# Access Compliance Report

## Public Rights-of-Way

Intersection ID: 43750	Main Street: POTTERS_GLEN_RD	Cross Street: EARTHENWARE_DR	Location:	N
ADA ID: 771D5787EDCE	Ramp Type: PerpDiag	Initial Pass/Fail: Fail	Overall Compliance: No	Severity Score: 25
Codes/Mitigation Info/Possible Solution		Field Measurements/Component Compliance

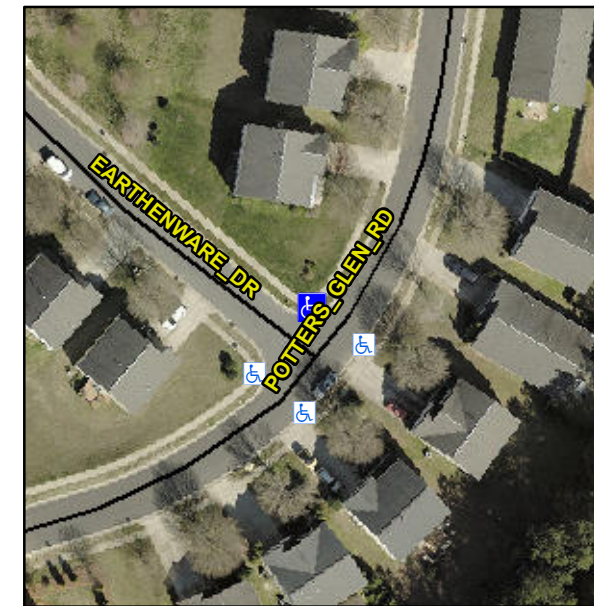
**Remove & Replace Curb Ramp With Two New Directional Ramps or Equivalent.**

**R304.5.1, R304.5.3, R302.7**

Compliance	Description	Data	Compliance	Description	Data
N/A	Ramp Length (in)	47.5	Yes	Ramp Slope (%)	6.6
No	Ramp Width (in)	36.0	No	Ramp XSlope (%)	2.4
N/A	Flare Type LT	N/A	N/A	Flare Type RT	N/A
N/A	Flare Slope LT (%)	N/A	N/A	Flare Slope RT (%)	N/A
N/A	Flare Traversable LT?	N/A	N/A	Flare Traversable RT?	N/A
N/A	Landing Length (in)	N/A	N/A	DWS Provided?	N/A
N/A	Landing Width (in)	N/A	N/A	DWS Contrast?	N/A
N/A	Landing Slope (%)	N/A	N/A	DWS Length (in)	N/A
N/A	Landing X Slope (%)	N/A	N/A	DWS Full Width?	N/A
N/A	Landing Curb? (Y/N)	N/A	N/A	DWS Offset (in)	N/A
N/A	Shared Landing?	N/A			
N/A	Gutter Ponding?	N/A	N/A	Gutter Slope (%)	N/A
N/A	Gutter Lip Ht (in)	N/A	N/A	Gutter X Slope (%)	N/A
N/A	Painted X Walk1?	No	N/A	Painted X Walk2?	No
	X Walk 1 Direction	To SW		X Walk 2 Direction	To SE
N/A	X Walk 1 Width (in)	N/A	N/A	X Walk 2 Width (in)	N/A
	X Walk 1 Slope (%)	5.8		X Walk 2 Slope (%)	6.2
	X Walk 1 X Slope (%)	0.7		X Walk 2 X Slope (%)	0.6

N/A	Ramp inside XWalk1?	N/A	N/A	Ramp inside XWalk2?	N/A
	Road Slope (%)	1.4	N/A	Clear Space?	N/A
	Road X Slope (%)	6.6	N/A	Clear Space to XWalk (in)	N/A
N/A	Any Obstructions?	N/A	N/A	Storm Grate/Utility Hazard?	N/A
	Obstruction Type			Storm Grate/Utility Type	
		N/A			N/A
		No		Surface Condition? (G/P)	Poor
